EOG Y Resources requests permission to plug this well using the attached procedure. The current and proposed wellbore schematics are attached.

Dixon & Yates LM Federal #2
660' FNL & 1650' FWL
Sec. 28-18S-29E
Eddy County, New Mexico
API # 30-015-32814

P&A Procedure
AFE # 108344

Proposed:

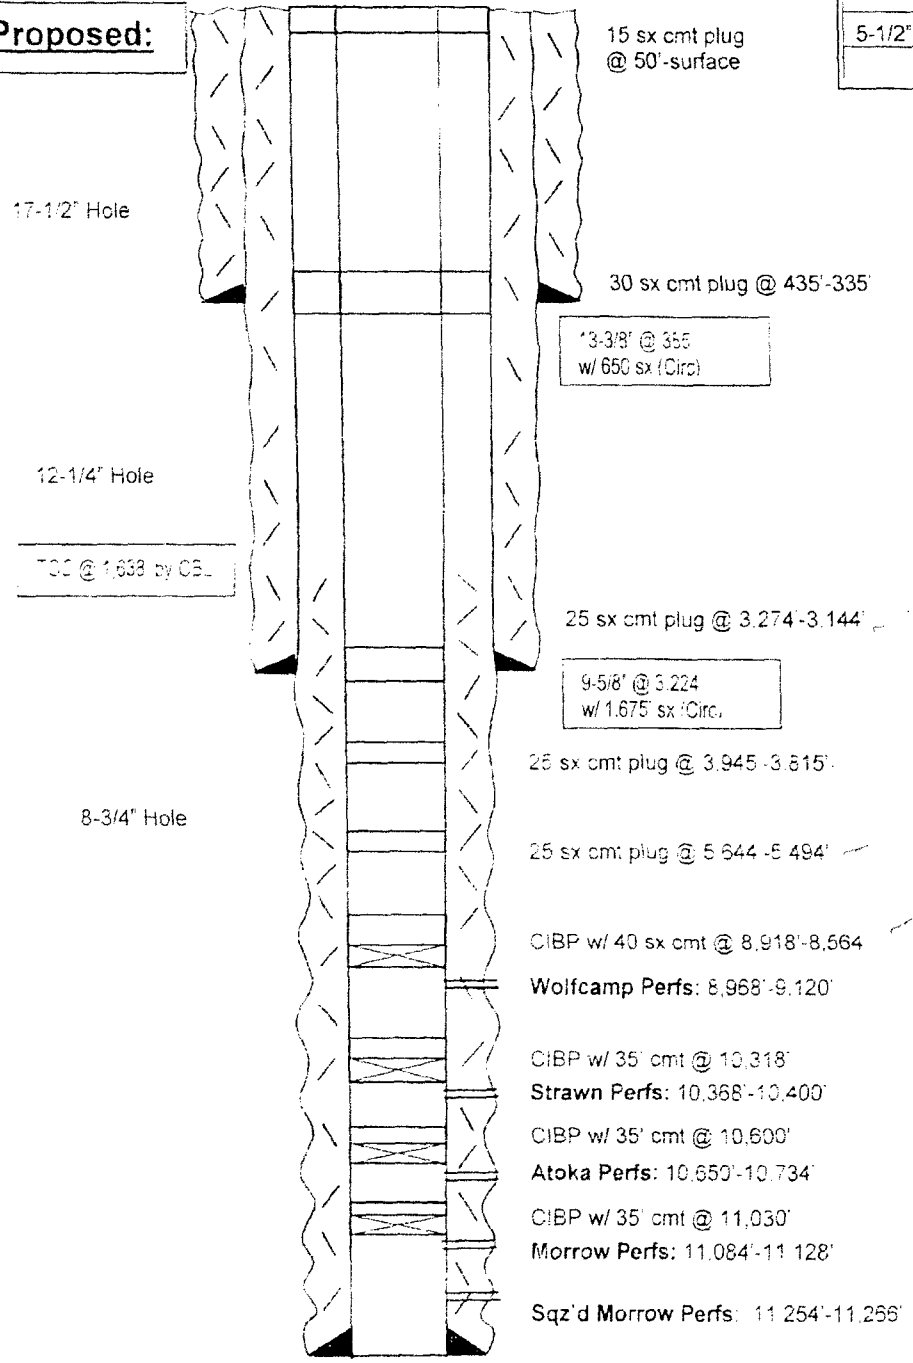
6. *Add Aug. Perf @ 1026' SQZ cmt to 926' WOC Tag*
RU WL to RIH and tag TOC, then pull up and perf 5 1/2" csg at 435'. POOH. TIH with 5 1/2" packer, set packer at 335' and *spot* a 100' (≈ 30 sx) class "C" cement plug from 435'-335' inside and outside 5 1/2" casing (this will cover 13 3/8" csg shoe). Release packer, pick up, reverse tbg clean and POOH to WOC.

7. *SQZ To Surf.*
RU WL, RIH to tag TOC, then perf 5 1/2" csg at 50'. POOH. Circulate 15 sx class "C" cmt from 50'-surf.
8. RDMO well service unit, cut off wellhead, install dry hole marker and clean location.
